**RE: *Waste Rock Storage Facility 6 Design Report for 2AM-MEL1631 water licence***

Agnico Eagle Mines Limited (Agnico Eagle) thanks the Nunavut Water Board (NWB) for the opportunity to address comments received for Agnico Eagle's Meliadine Gold Mine Waste Rock Storage Facility 6 Design Report.

250113 2AM-MEL1631 REP-WRSF6 Design Report-IFU ECCC Comments-IMLE

FIGURE 1

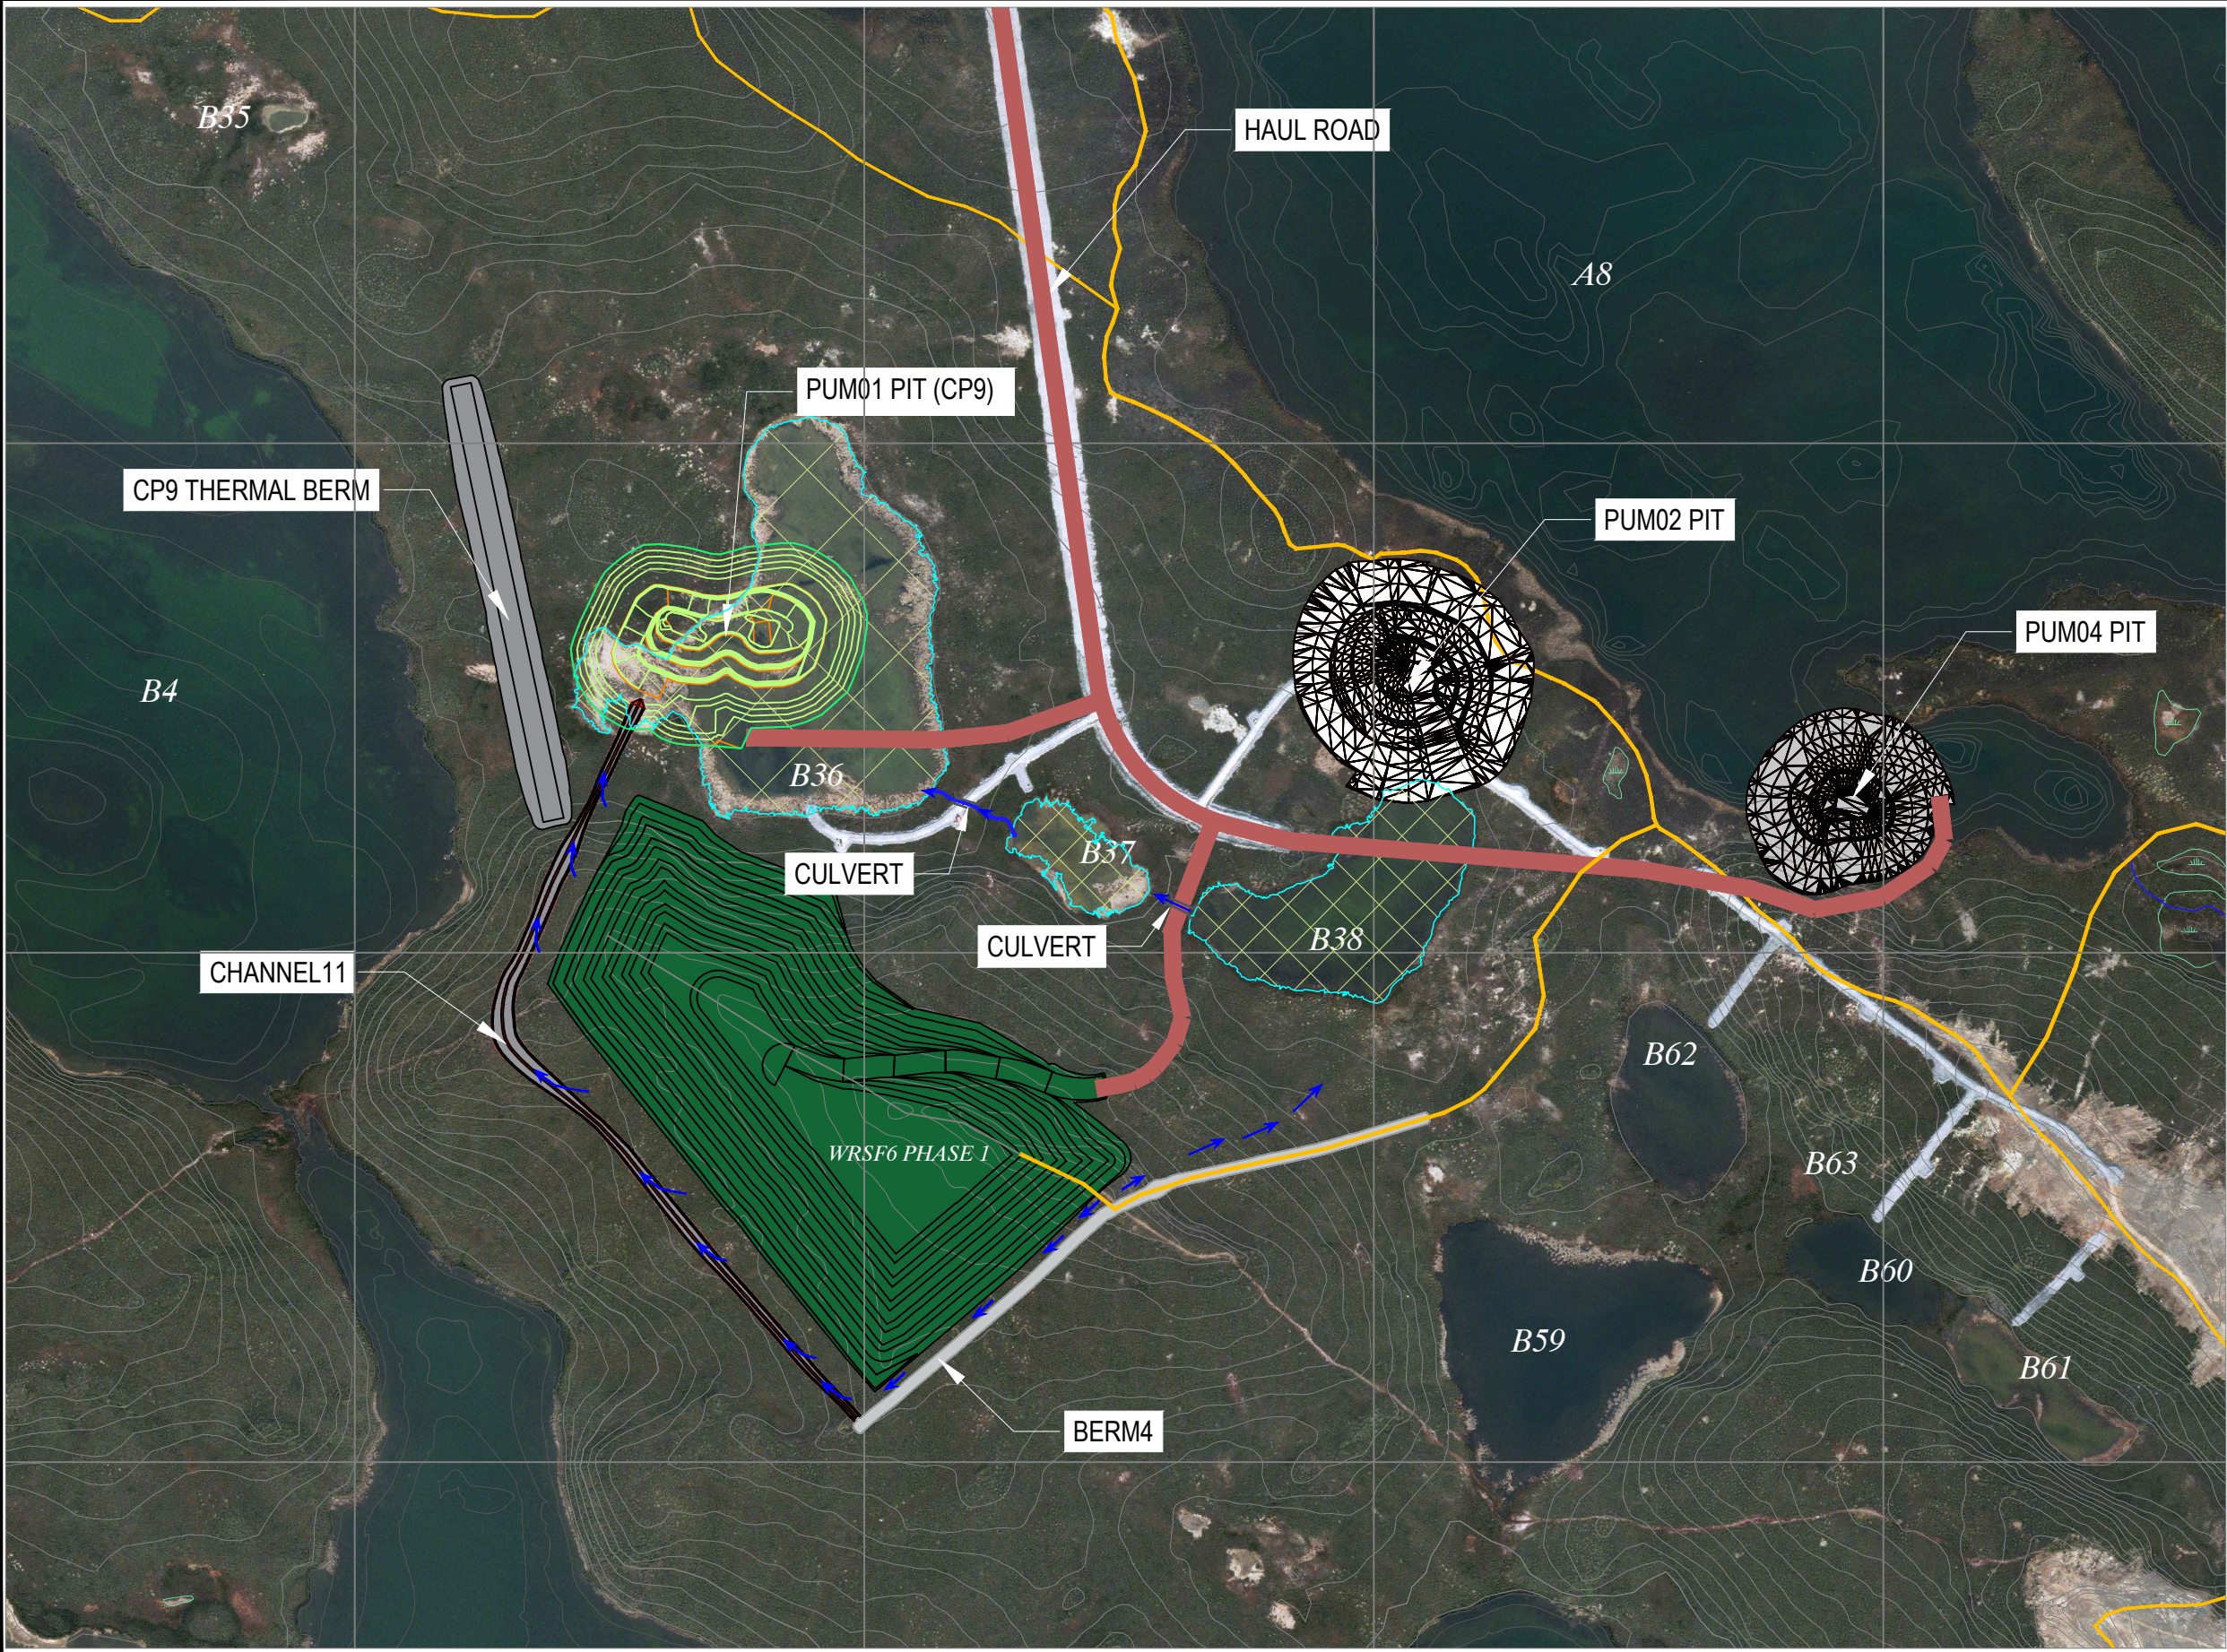
**ECCC-1: DRAINAGE FROM EAST SIDE OF WASTE ROCK STORAGE FACILITY 6**

Section 7.0 of the Report describes how seepage and runoff from Waste Rock Storage Facility #6 (WRSF6) will all report to collection pond CP9 for Phase 1. It states, “*Seepage and runoff from the north and southeast portions of WRSF6 Phase 1 will naturally flow or be redirected by a diversion berm to CP9.*” It is not clear from the figures presented if runoff diverted by Berm 4 would drain towards Lake B62 or former Lake B38. Nor is it clear how water accumulating in these areas and in former Lake B37 would make its way to CP9. If water diverted by Berm 4 flows towards Lake B62, it could be necessary to manage potentially sediment laden water to prevent it from entering fish bearing waters since Sump 5 will not be constructed until Phase 2.

ECCC recommends the Proponent provide more details on how runoff and seepage from the eastern side of WRSF6 will be directed to CP9, including:

- flow paths of water diverted by Berm 4.
- how any runoff flowing from the WRSF towards Lake B62 will be managed, if this is predicted to occur.
- where water flowing from the eastern side of WRSF6 will accumulate; and
- how water accumulating in former Lakes B37 and B38 will be managed

Agnico Eagle thanks ECCC for their comment. Figure 1 at the end of this document presents the water flow paths and how runoff and seepage from the eastern side of WRSF6 (Phase 1) are to be diverted to CP9 (Pump 01 Open Pit).

As shown in Figure 1, water diversion Berm 4 for WRSF6 Phase 1 is on the natural catchment boundary which separates the catchment area for Lake B62 and former Lake B38, as a result, runoff water from the northeast portion of WRSF1 Phase 1 will naturally flow by gravity or be diverted to former Lake B38 by Berm 4. Runoff water from WRSF6 Phase 1 is not expected to flow to Lake B62 and downstream Lake B59.

Under baseline conditions, water in former Lake B38 naturally flows to former Lake B37 and then flows to former Lake B36 where CP9 will be formed in Pump 01 Open Pit. As per the current mine development plan, haul roads will be constructed across the narrows between former Lake B36 and former Lake B37 and between former Lake B37 and former Lake B38. When the haul roads are constructed, culverts<sup>1</sup> (as shown in Figure 1) will be installed in the haul roads at the original water flow locations to divert the water collected in the former Lake B38 to former Lake B37 and then CP9.
